APPEAL SUMMARY

Appeal ID: 15351	Project Address: 901-919 SW Taylor St
Hearing Date: 7/12/17	Appellant Name: Halla Hoffer
Case No.: B-009	Appellant Phone: 9713523933
Appeal Type: Building	Plans Examiner/Inspector: John Cooley
Project Type: commercial	Stories: 9 Occupancy: A-2 and B Construction Type: III-B
Building/Business Name: Studio Building	Fire Sprinklers: Yes - All Levels
Appeal Involves: Alteration of an existing structure	LUR or Permit Application No.: 17-179964-CO
Plan Submitted Option: pdf [File 1] [File 2]	Proposed use: Office/Restaurant

Replacement of seven original non-protected windows on property line with sprinkler protection provided in lieu of fire rated glazing: Granted as proposed.

Studio Building - Window Replacement

G-105

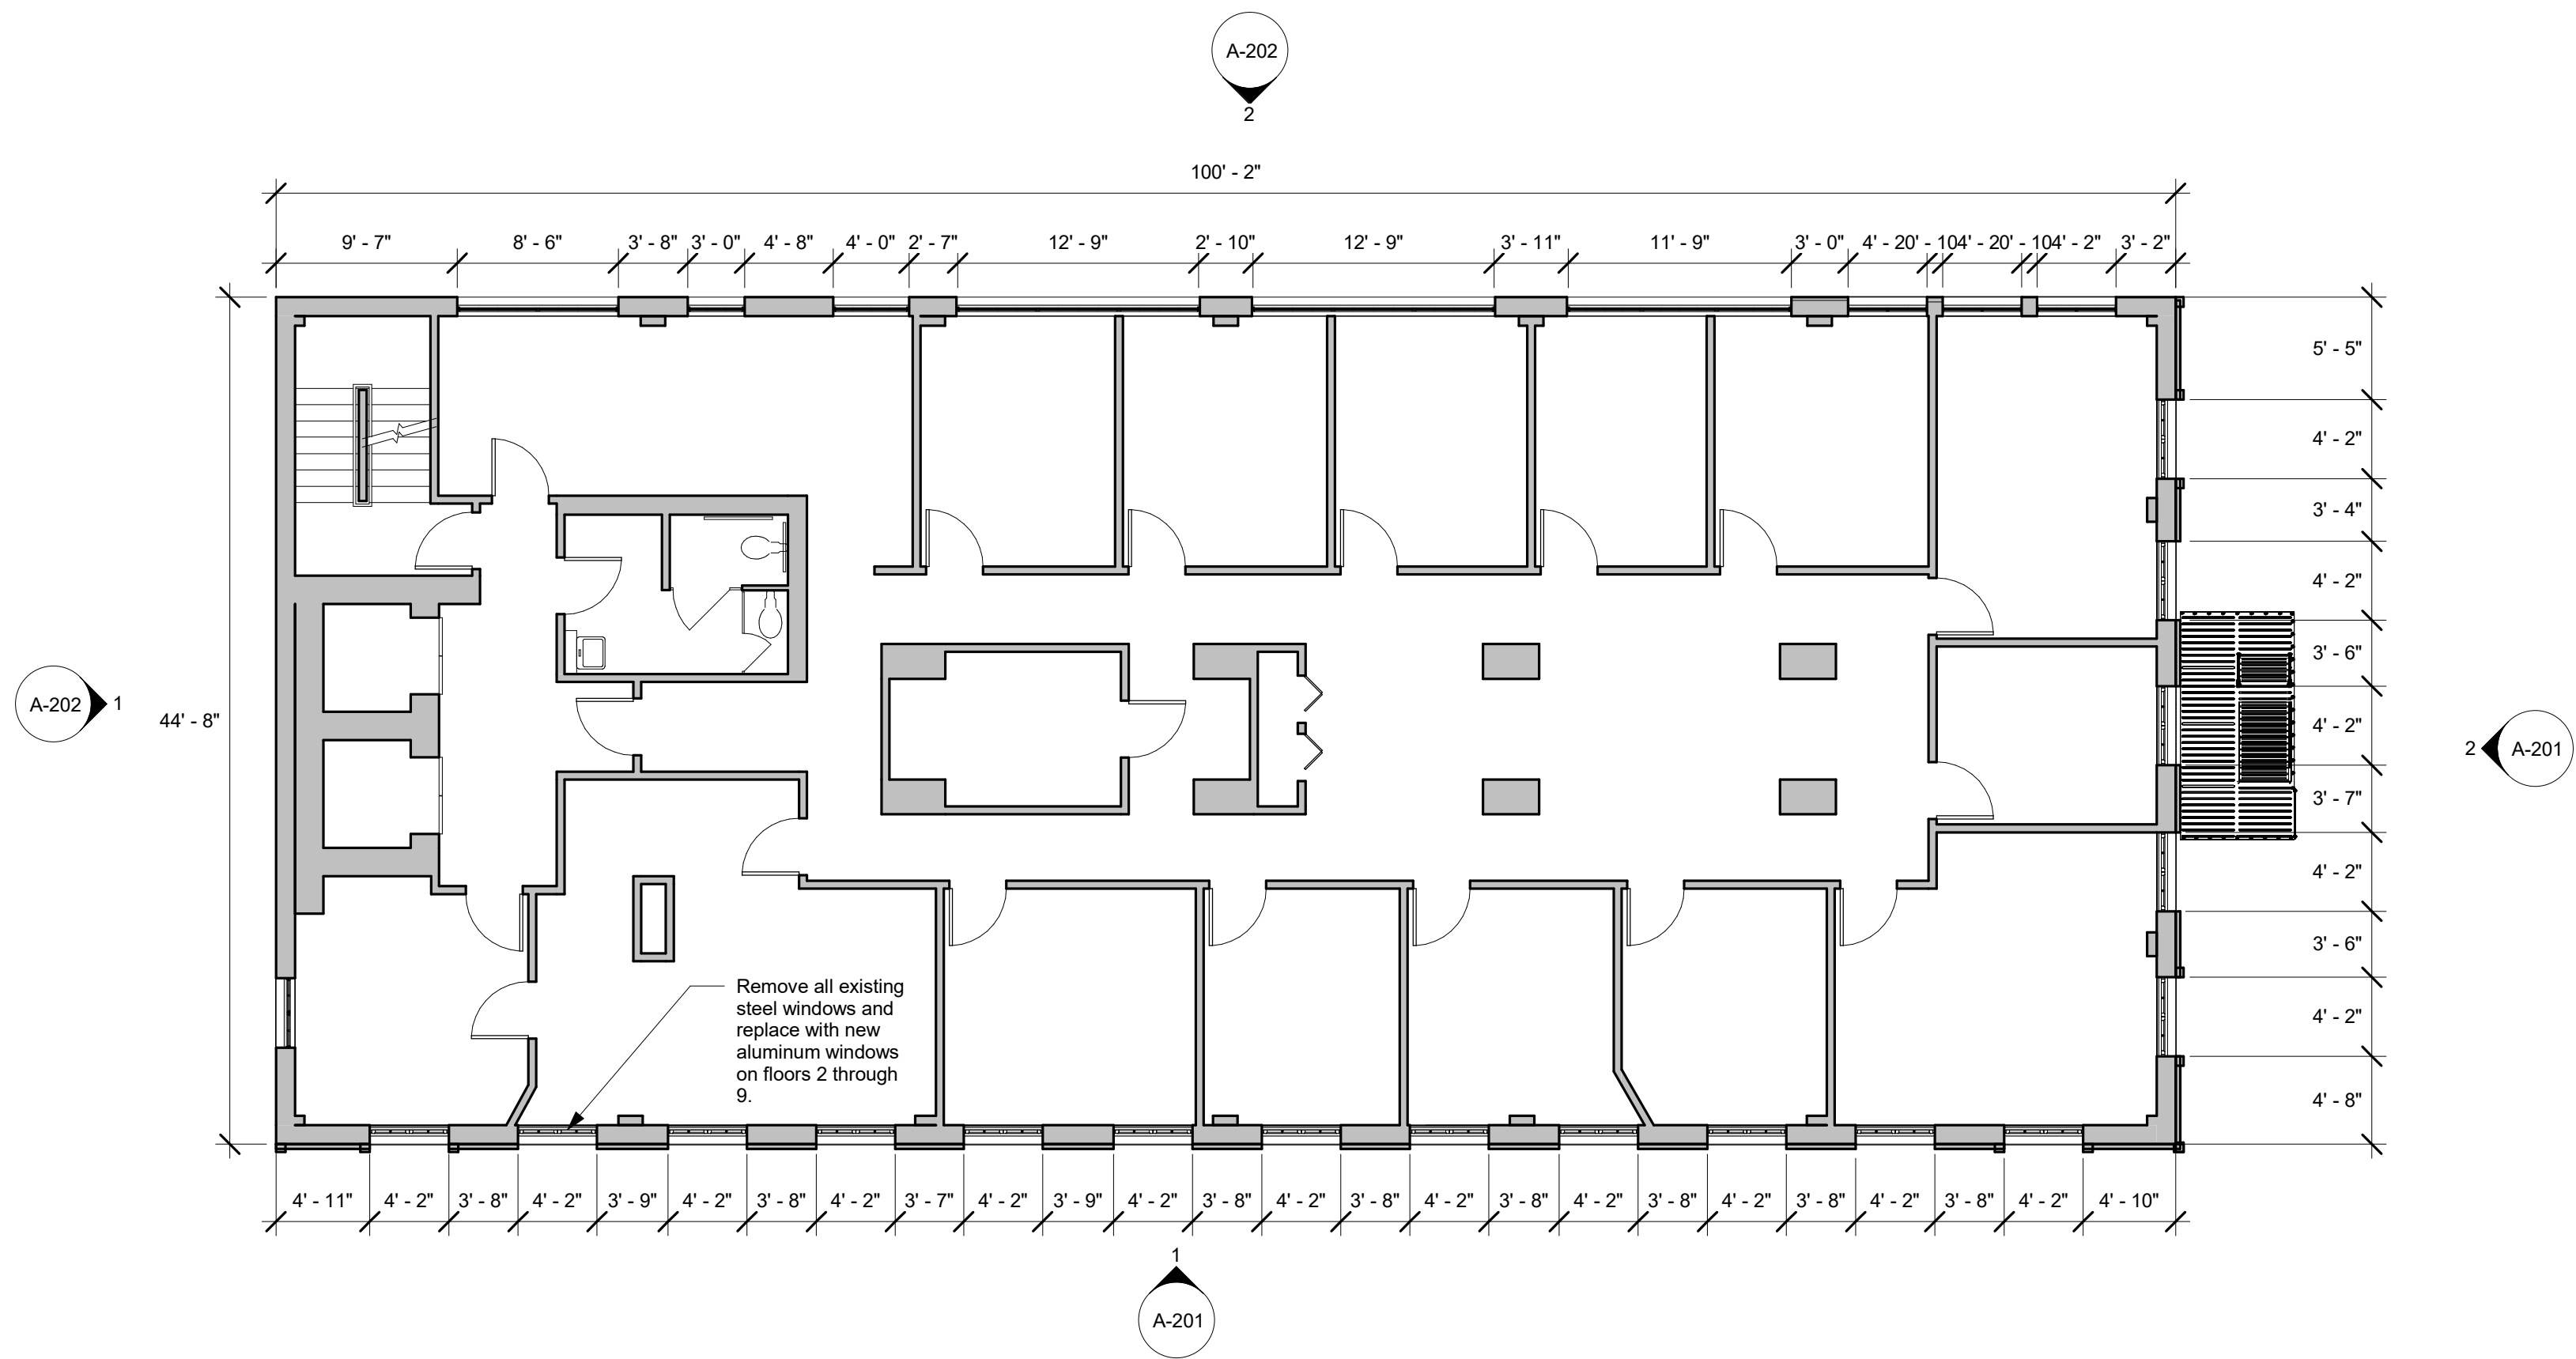
the west. The adjacent structure appears to be Type IIIB construction. The roof level of the adjacent building is located below the lowest windows on the lot line. The occupancy in the building on floors 2 - 9 is type B. The lot line windows are not immediately adjacent to egress stairs, see attached drawings (Sheet G-105) for a typical floor plan.

A-202

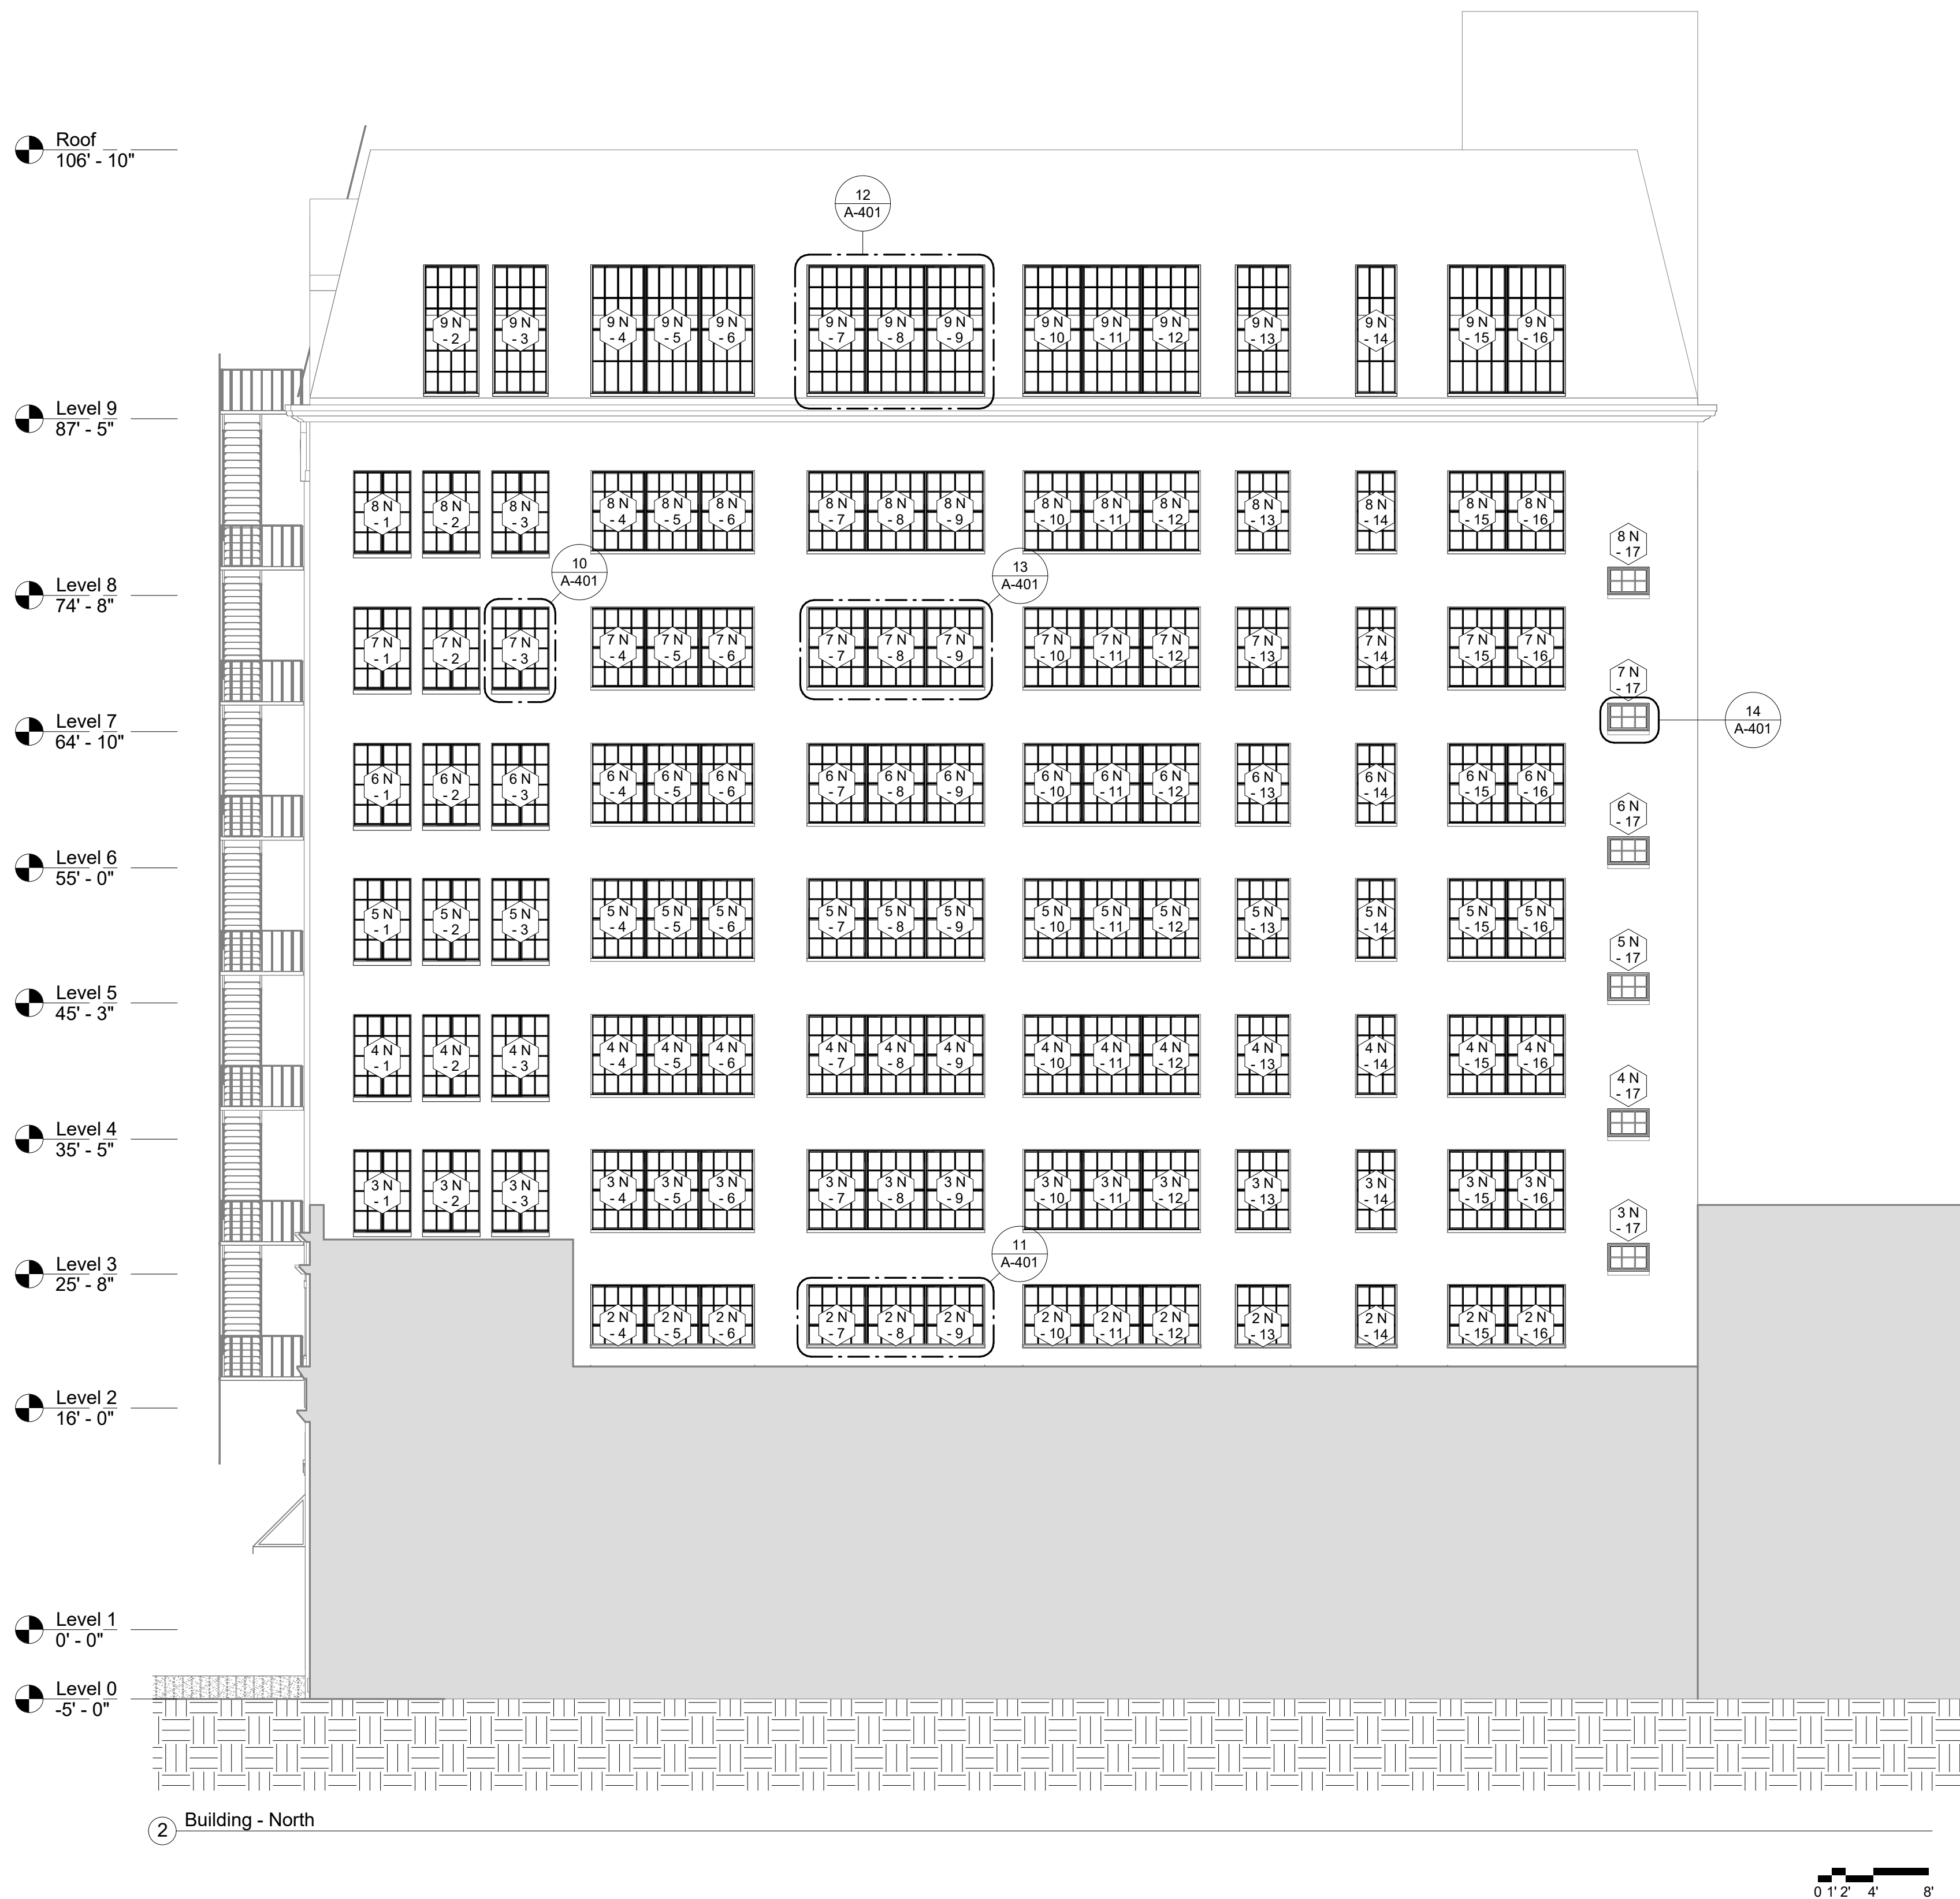
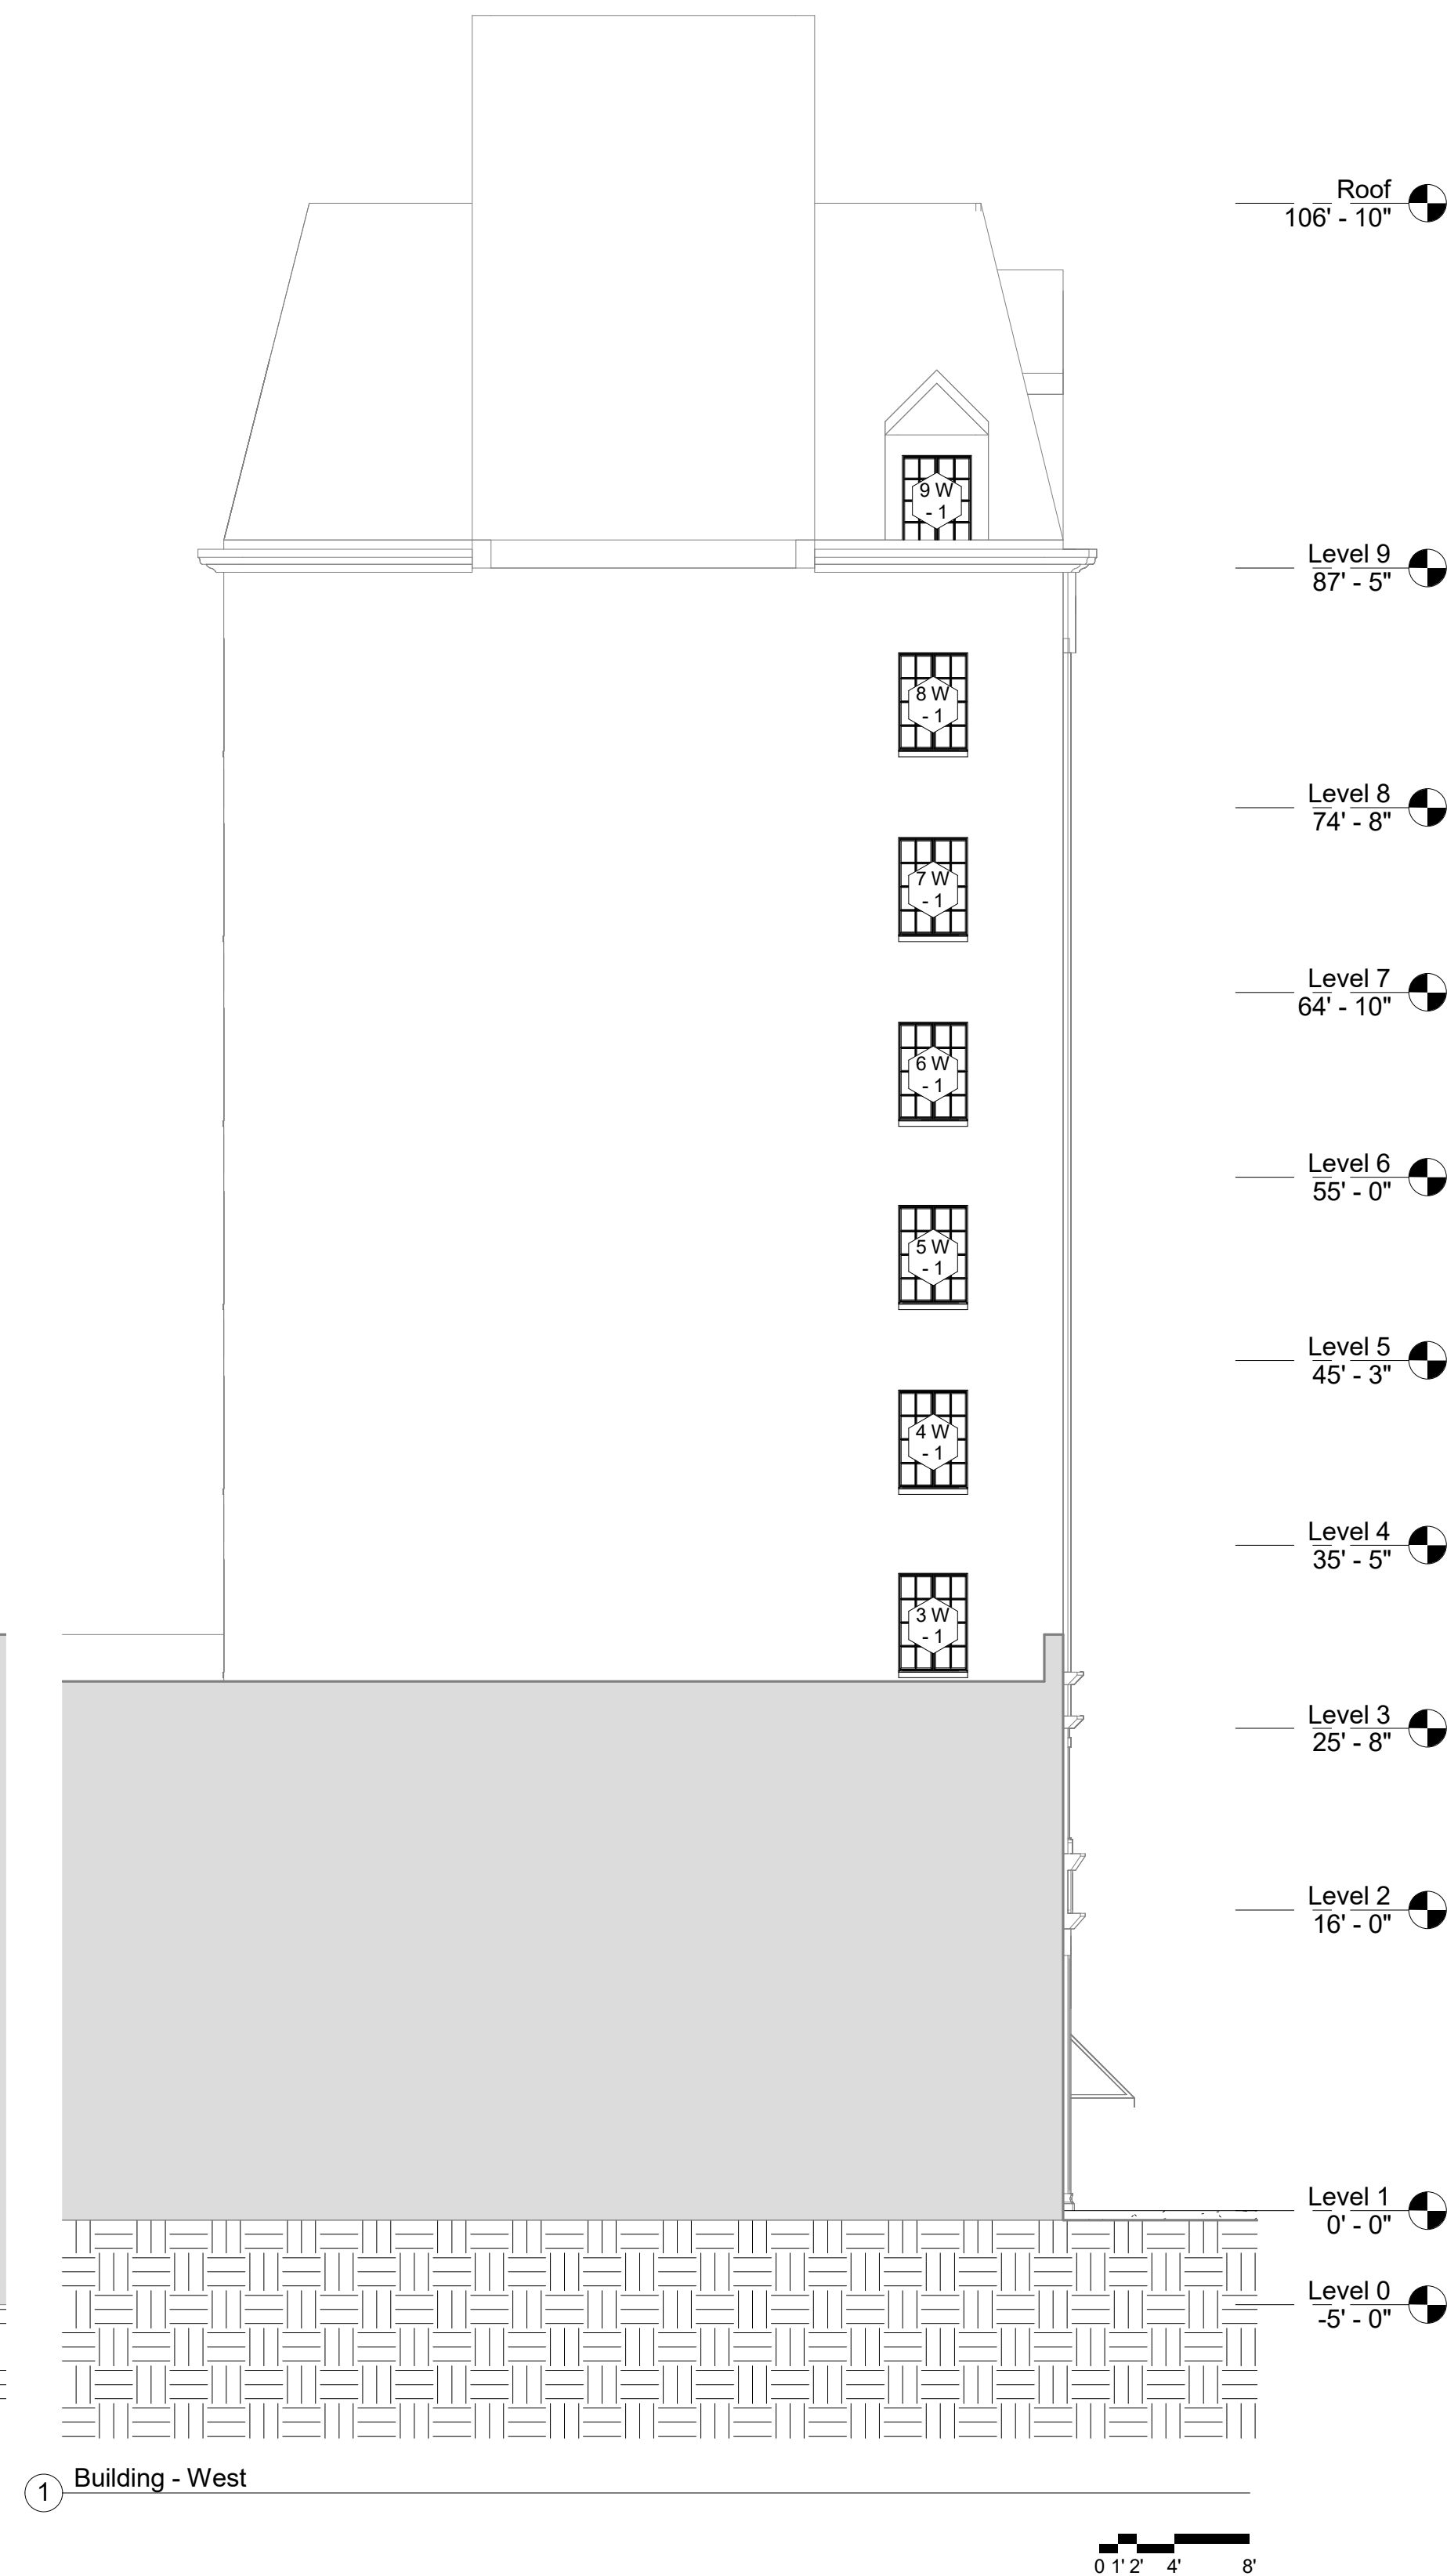
Reason for alternative	The existing building is Type IIIB and fully sprinklered. The seven (7) lot line openings in question on the west elevation are original to the building and have not been altered. Attached historic documentation dated September 1926 shows the existing units in their current configuration. The lot line windows are located in a single column along the southern edge of west elevation and located on floors 3-9. The rest of the west elevation is exposed coated concrete 8" thick. The openings total less than 5% of the west elevation. A two-story structure sits on the adjacent lot to
